Re: Proposed Warkworth South Plan Change – Response to CI 23 Request

Warkworth South Plan Change : Clause 23 Responses.

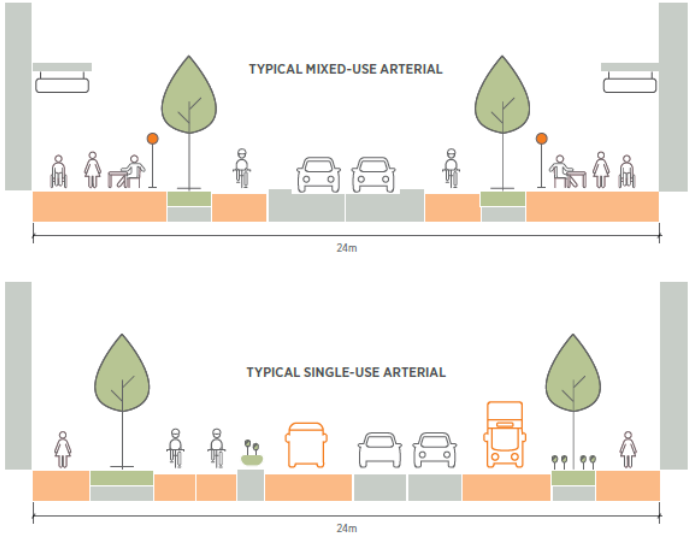
Transport			
<u>Future Traffic Flows</u>			
4.1	Please undertake an assessment for 2046 to demonstrate that the proposed Sh1/WWLR	TPC	As stated in Section 3.3 of the ITA report, the SGA have undertaken assessment of the road network required to accommodate the traffic generated by the full

<p>intersection operates satisfactorily in 2046, or whether upgrades to the intersection may be required. If upgrades are required, the precinct should ensure that those upgrades are no precluded.</p> <p>The ITA focuses on the short to medium term effects of the plan change. No assessment of the long term effects within the full build out of the plan change in considered in 2046, other than reliance on the previous work undertaken in the Warkworth Structure Plan (WSP).</p> <p>The assessment in the WSP was a high level assessment and there is now more detailed information available with regards to the development and the roading network for Warkworth South; for instance, the Wider Western Link Road now connects to SH1 as a cross-roads with a collector road to the east of SH1. Previously, this road was a T intersection.</p> <p>The assessment should ensure that the proposed intersection with SH1 which provides the main access to the plan change area would continue to operate satisfactorily in 2046 or identify whether an upgrade (or additional land) would be required.</p>		<p>development of Warkworth in 2046, and this work has not been repeated in the ITA report.</p> <p>SGA have verbally advised the applicant that a single lane roundabout would accommodate WWLR/SH1 traffic following the full development of FUZ land and a completed arterial road network. As shown below, SGA have recently shared their idea for a layout of the Western Link Road/SH1 intersection proposal to support their upcoming Notice of Requirement and which shows a single lane roundabout.</p>
